BOARD OF SUPERVISORS

AGENDA

Reference: 160 Park Road (Gunner Properties, L.t.d.)
Preliminary/Final Land Development Application Review
Upper Uwchlan Township, Chester County, PA

- Transmittal Cover Letter prepared by Riley, Riper, Hollin & Colagreco, dated July 3, 2019.
- Preliminary/Final Land Development Application dated July 3, 2019.
- Waiver Request Letter prepared by D.L. Howell & Associates, Inc., dated July 3, 2019.
- Response Letter prepared by D.L. Howell & Associates, Inc., dated June 28, 2019.
- Plan set consisting of twelve (12) sheets titled "Preliminary/Final Plan," prepared by D.L. Howell & Associates, Inc., dated April 25, 2019, last revised June 5, 2019.
- Report titled "Stormwater Management Report for Eagle Village Parking Expansion," prepared by D.L. Howell & Associates, Inc., dated June 20, 2019.

**Detail of Eagle Village Parking Expansion
Preliminary/Final Subdivision and Land Development Plan**

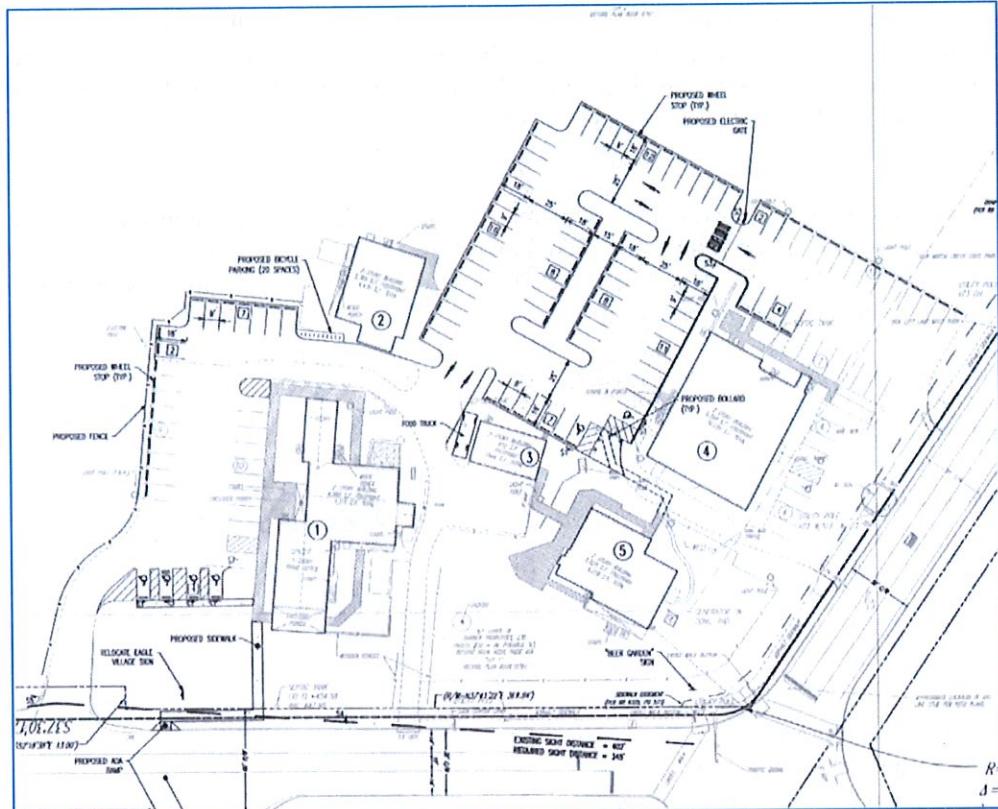
3. The Township may wish to inquire why an electric gate is proposed at the eastern entrance to the new parking area; we note that there is no electric gate proposed for the other entrance.
4. We have no comments on the design of the proposed lot consolidation.
5. The Township should ensure that sidewalks are provided along the frontages of North of Park Road and Pottstown Pike. Sidewalks are an essential design element for new construction in the **Suburban Center Landscape**. Also, “Connect” Objective C of *Landscapes3*, the 2018 County Comprehensive Plan, is to provide universally accessible sidewalks, trails, and public transit connections to create a continuous active transportation network within designated growth areas.
